1964 Corvette: Service Bulletin: Neutral Safety Switch Malfunction

Subject: Neutral Safety Switch Malfunction

Model and Year: 1964 Corvettes with Powerglide Transmissions

Bulletin No: DR #658

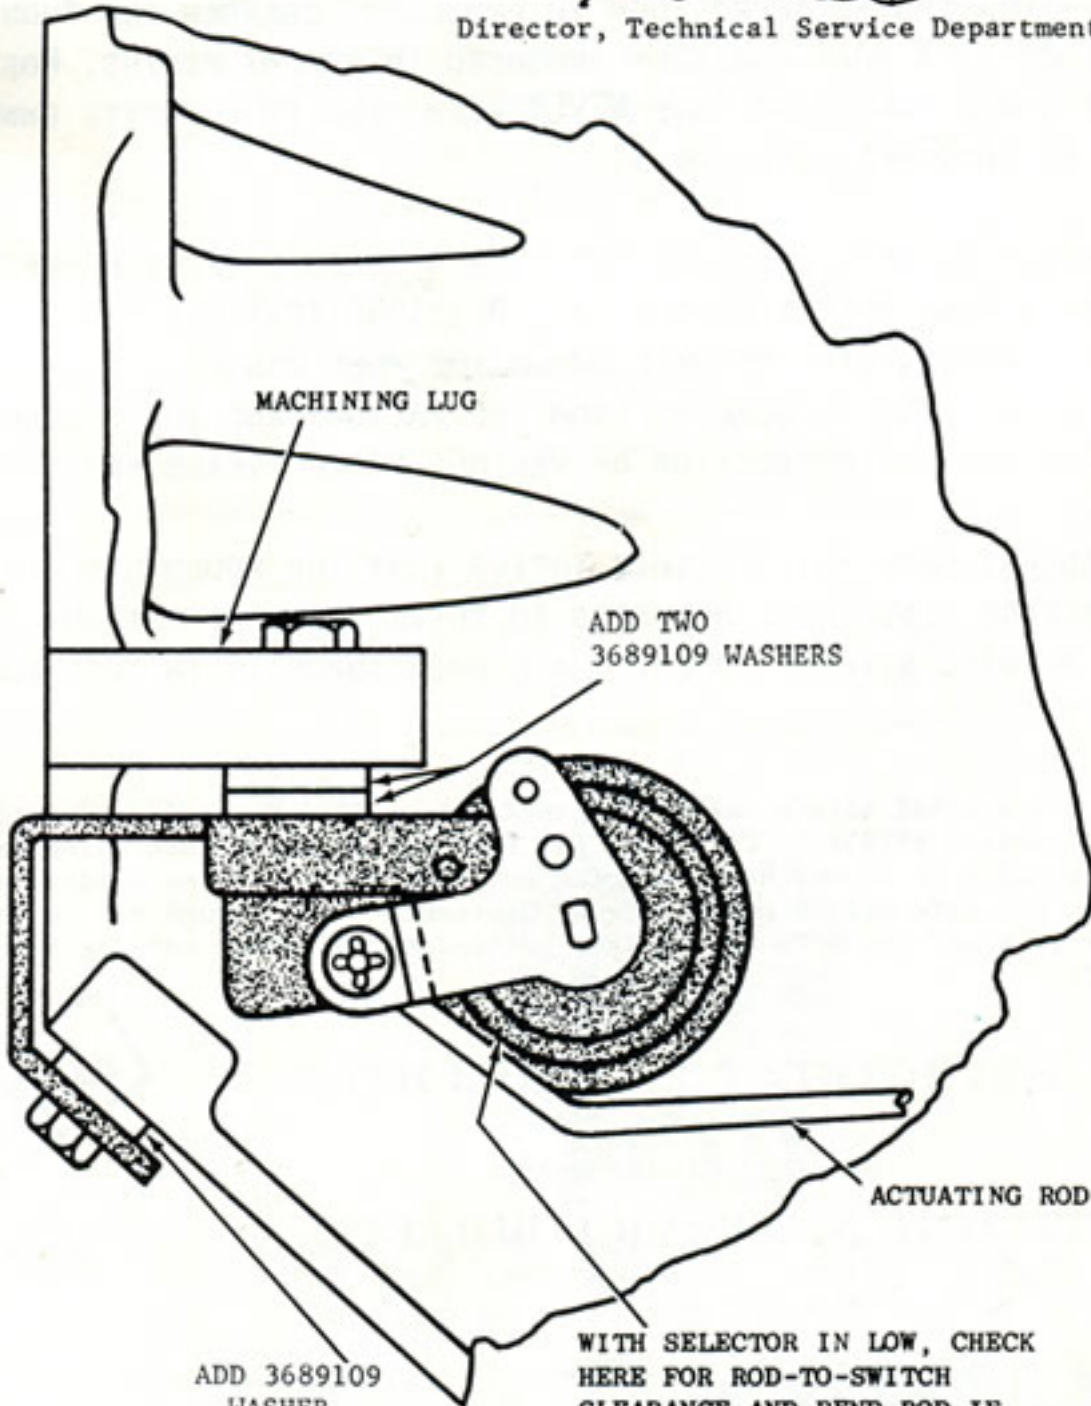
Interference between the neutral safety switch and the underbody may exist on some early production Corvette Models with Powerglide transmissions.

This could result in the engine being started while the transmission selector is in a drive position. In addition, the added load imposed on the shift linkage by the misalignment causes a reduction or loss of detent feel when the transmission is shifted manually. The transmission might then be accidentally operated between ranges and internal damage could result.

Correction of switch malfunction may be made by shimming the switch assembly downward as shown in the attached sketch. Note that operating clearance must exist between the switch body and the switch actuating rod after the shimming operation is completed.

WITH SELECTOR IN LOW, CHECK
HERE FOR ROD-TO-SWITCH
CLEARANCE AND BEND ROD IF
NECESSARY. TEST ACTION OF SWITCH
AFTER BENDING ROD & ADJUST LENGTH
OF ROD AS REQUIRED BY TURNING
THREADED PIVOT.
